INDESIT company

Model type:
AB60IT

Commercial code:
F026971

FIG. 1

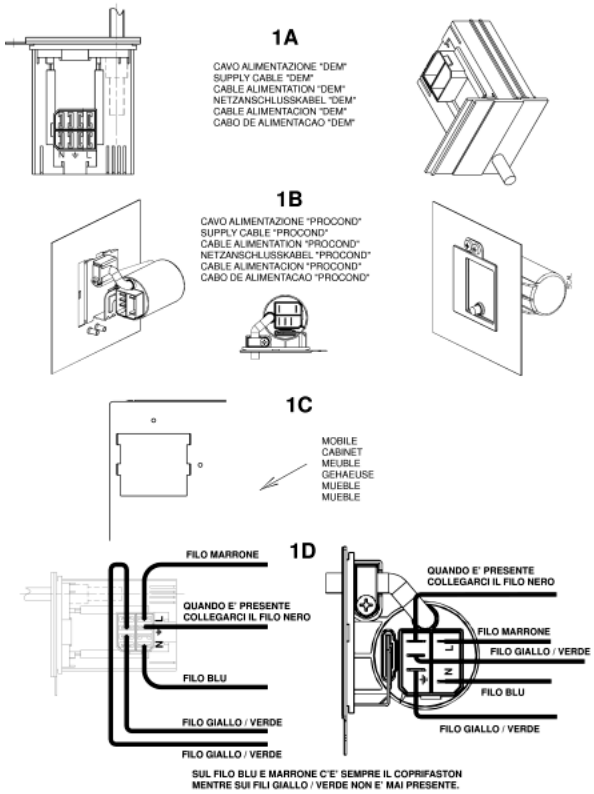
From serial no. 21015.001, a heater retaining element bracket (see fig.3) has replaced the heater retaining element protection Sat code 055036 (see fig.4) on all plastic tanks installed in washing machines produced in the Teverola factory.

The new part (fig. 1A) is fixed to the bowl with a self-tapping screw from the inside outwards and differs from the one used in the Comunanza factory (fig. 1B) in the fixing hole which is not threaded.
In order to reduce the number of parts used, only kit 058523 is managed and which, if used on the Teverola washing machines, must be fixed with a self-tapping screw, instead of metric, after widening the tapped hole with a suitable drill bit.
When inserting the heater retaining element, particular care must be taken so that it is fitted correctly (Fig. 3).
The plastic tanks to be arranged for the guide have the same Sat code as those with the protection.

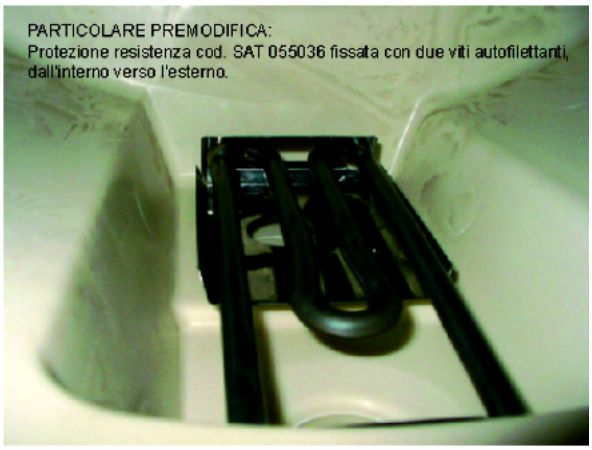
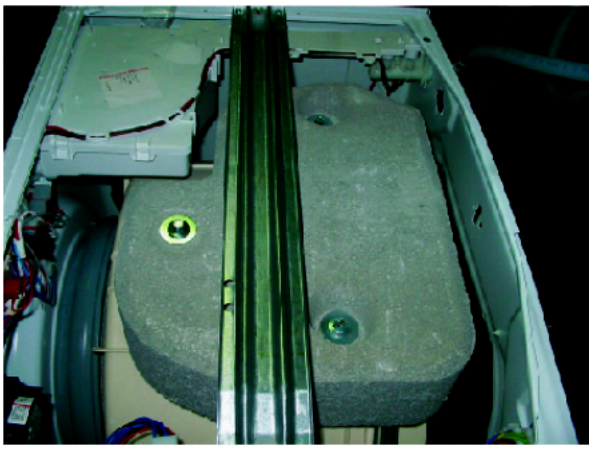
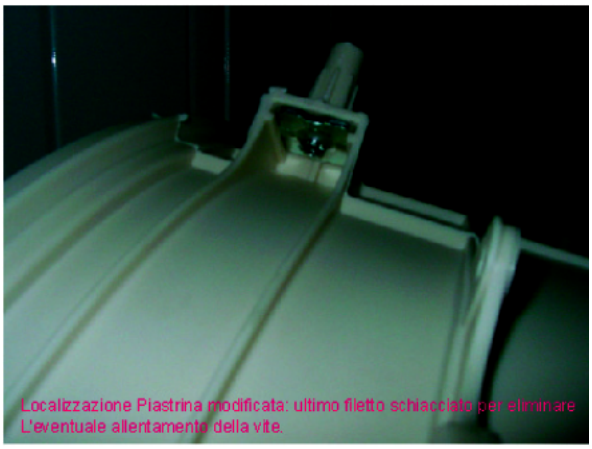
>From serial no. 21121.0001, the counterweight Fig. 2B with outlet increased by 5 mm in the centre has replaced the previous counterweight Fig. 2A.
The new counterweight (fig. 5) is fixed using three M8 X 63 mm screws with washer code 092016 (see fig. 8) and three plates with the last thread flattened (fig. 6) to prevent accidental loosening of the screw.
All the plates code 055038 in stock in the Centralised Warehouse have been replaced and can also be used on premodification appliances.
The modified counterweight has the same Sat code as the premodification item (066615) that will be managed until stocks run out.
The new counterweight must be assembled using the new screws and plates (see fig. 7).
Both counterweights can be employed necessarily using the following fixing parts which are specific for each type of counterweight:

AVVERTENZE:
Nuova **guida resistenza** introdotta il 15-10-02.
Al momento **dell'inserimento** della **Resistenza, fare attenzione** affinchè **questa venga montata correttamente, così** come raffigurato in foto, **in quanto esiste** la reale possibilità **che questa possa essere montata al di** sotto dell' anello **intmedio della "campanella"** e che quindi **la resistenza** andrebbe **a contatto** diretto con la plastica.

PARTICOLARE PREMODIFICA:
Protezione resistenza cod. SAT 055036 fissata con due viti autofilettanti, dall'interno verso l'esterno.

Fixing parts for premodification counterweight (see fig. 9):
3 pieces code 055019 - Screw M8 X60 mm;
3 pieces code 055018 - Conical washer;
3 pieces code 034336 - Flat washer;

Fixing items for modified counterweight:
3 pieces code 092016 - Screw M8 X 63 mm with washer;
3 pieces code 055038 - Plate with last thread flattened;

Particolari per il fissaggio del contrappeso modificato:
N° 3 pezzi del cod. 055038 – Piastrina con ultimo filetto schiacciato per evitare l'eventuale allentamento del perno.

Localizzazione Piastrina modificata: ultimo filetto schiacciato per eliminare L'eventuale allentamento della vite.

Particolari per il fissaggio del contrappeso modificato:
N° 3 pezzi del cod. 092016 – Vite M8X63 mm con rondella incorporata.

Particolari per il fissaggio del contrappeso premodificato:
N° 3 pezzi del cod. 055019 – Vite M8X60 mm,
N° 3 pezzi del cod. 055018 – Rosetta conica,
N° 3 pezzi del cod. 034336 – Rondella piana.

FIG. n1040305fig01

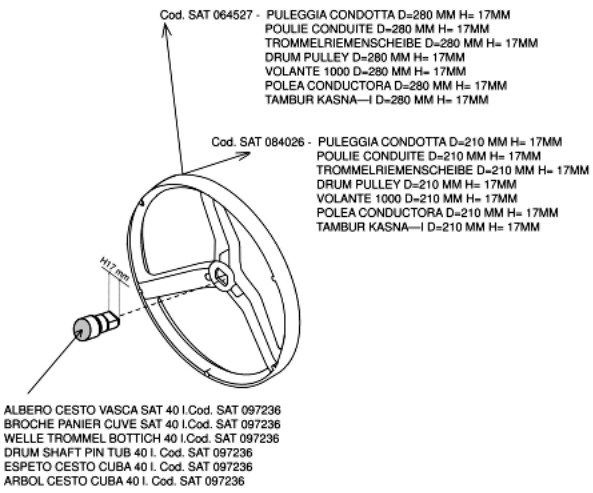
Since August 2003, the following modifications are gradually being made to the oscillating unit on 2000 range models produced in the Teverola factory:
Gradual use of the EVOII 40 litre plastic bowl (code 097236) which differs to the previous LB2000 version, for the following characteristics:
1) Assembled with basket and welded bowl lid;
2) Elimination of detergent recovery tube hole (where provided);
3) Diameter 30 cm opening instead of 28 cm;
The last two numbers of the Industrial Code (given on the rating plate) of the models relevant to this system will be 30 (e.g. 46268790030)
This modification has involved the use of a new table for the oscillating unit (1140240) in the documentation of the relevant models, and for the appliances the following parts have been used:

·Pressure switches:
Code 096880 - Pressure switch one level 100-75 + overflow Rast 5;
Code 097735 - Pressure switch one level 185-80
Code 097746 - Pressure switch two levels 130-100 200-105 RST 5
·Resistance 1700/230 Rast. 2.5 (code 094715);
·Induction motors 2/16 poles (code 066087), 2/12 poles (code 075892) and 2/12 poles 60 Hz (099101);
·Eeproms - The new software for the 40 litre EVO washing machines can also be used on premodification appliances; it is managed with the same Sat codes as the previous software, which is being immediately replaced as the new models enter into production.
·Pulleys - The use of a single 40 litre bowl assembly in Assistance involves management of the pulleys used in production (097268 and 097267) and also those required for creating the various combinations (see fig. n1040305fig.01):

NB: From serial no. 31103.0001, all EVO appliances are equipped with a 40 litre bowl with H=15 mm drum cross shaft which will be managed with the same SAT code (097236) as the 40 litre bowl with H=17 mm shaft until stocks last.
To create the various combinations, the following pulleys are required:

Code 064527 - Pulley D=280mm H=17 mm;
Code 084026 - Pulley D=210mm H=17mm.

Code 097268 - Pulley D=280mm H=15 mm;
Code 097267 - Pulley D=210mm H=15mm.
Exceptions to this are models W93UK (23330) and W103UK (23334) which are equipped with a 46 litre bowl; therefore if the bowl needs replacing code 096198 with 20 mm pulley cross shaft must be used.
In production, pulley code 064527 (diameter D= 280 mm and central hole H= 17mm) is used; therefore, when replacing the bowl, code 097269 (diameter D= 280 mm and central hole H= 20mm) must be used.

Fig . 001

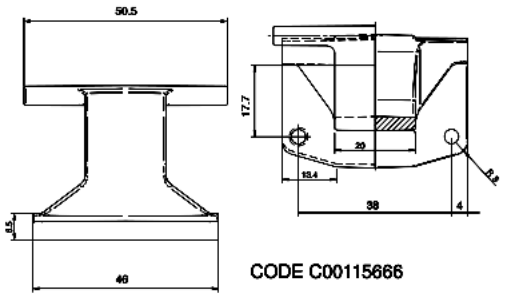
From serial no. 50207.0001, all Ariston models produced in the Teverola factory (see table 001 attached) with industrial code (given on the rating plate) starting with 46, have been equipped with a Zamac hinge with 150° opening angle, code C00115666 (see Fig.001).
This modification has involved the introduction of the following items:

The premodified items are not interchangeable separately with the modified ones.

Code C00115670 - Complete door EVOII 150° white 27 with standard glass;
Code C00115674 - Complete door EVOII 150° white 27 with long glass;
Code C00115667 - EVOII body for 150° hinge white 27;
